NO: PMS - 017	PRODUCT: EE-SX1131 – Photomicrosensor (Transmissive)
DATE: March 2017	TYPE: DISCONTINUATION – Streamline Product Offering

EE-SX1131 Photomicrosensor – DISCONTINUATION Replaced By New Product Model

Wire Connection:

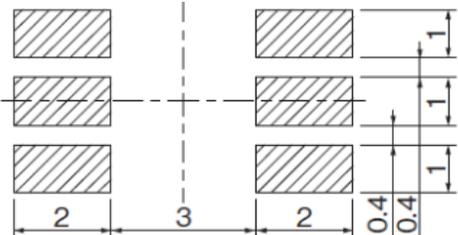
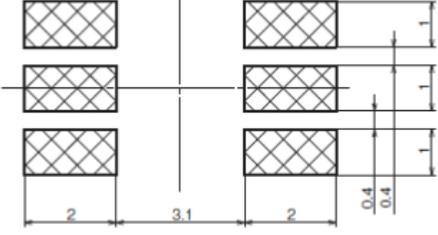
Discontinued Model EE-SX1131 (-1)	Suggested Replacement Model EE-SX1321																								
<p>Wire connection</p> <p>(Top View)</p>   <table border="1" data-bbox="228 1068 625 1346"> <thead> <tr> <th>Terminal No.</th> <th>Name</th> </tr> </thead> <tbody> <tr> <td>A</td> <td>Anode</td> </tr> <tr> <td>NC</td> <td>Not connected.</td> </tr> <tr> <td>K</td> <td>Cathode</td> </tr> <tr> <td>C</td> <td>Collector</td> </tr> <tr> <td>E1</td> <td>Emitter 1</td> </tr> <tr> <td>E2</td> <td>Emitter 2</td> </tr> </tbody> </table>	Terminal No.	Name	A	Anode	NC	Not connected.	K	Cathode	C	Collector	E1	Emitter 1	E2	Emitter 2	<p>Wire connection</p> <p>(Top View)</p>   <table border="1" data-bbox="1003 1136 1312 1346"> <thead> <tr> <th>Terminal No.</th> <th>Name</th> </tr> </thead> <tbody> <tr> <td>(1)</td> <td>Anode</td> </tr> <tr> <td>(2)(3)</td> <td>Cathode</td> </tr> <tr> <td>(4)(5)</td> <td>Emitter</td> </tr> <tr> <td>(6)</td> <td>Collector</td> </tr> </tbody> </table>	Terminal No.	Name	(1)	Anode	(2)(3)	Cathode	(4)(5)	Emitter	(6)	Collector

Dimensions:

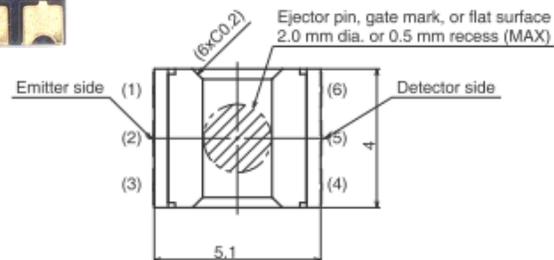
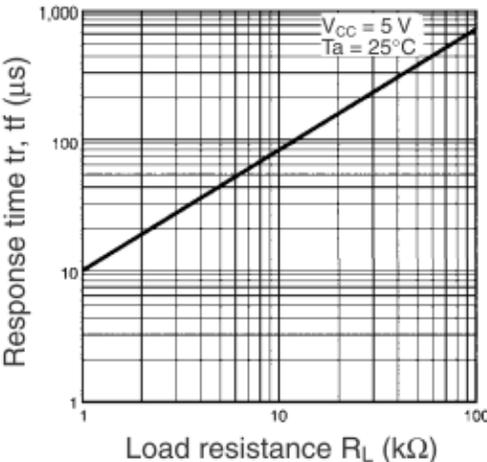
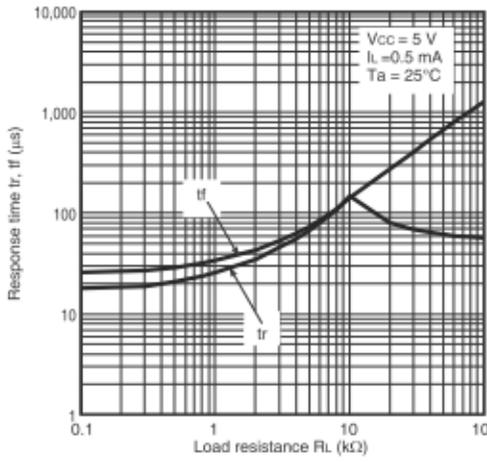
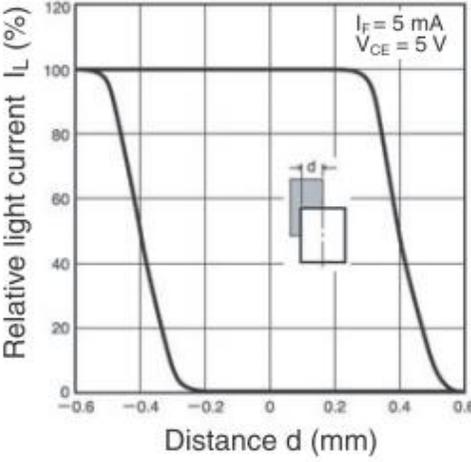
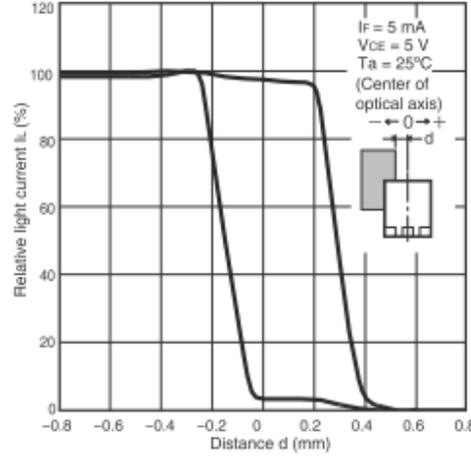
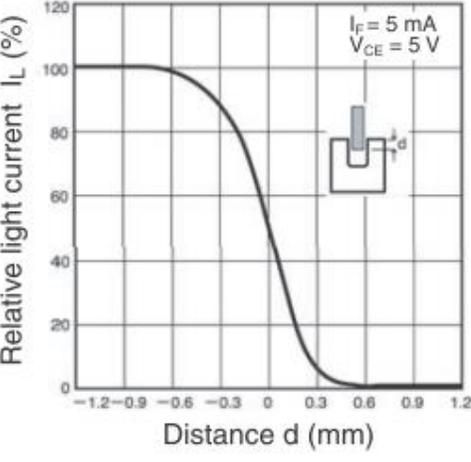
Slot width : 2mm

Dimensions(W × L × H) : 4mm × 5mm × 4mm

Emitter	Detector
1.5×1.5	1×0.3 2ch

Slot width : 2mm

Dimensions(W × L × H) : 4mm × 5.1mm × 4mm

Emitter	Detector
1.4×1.4	1×0.3 2ch
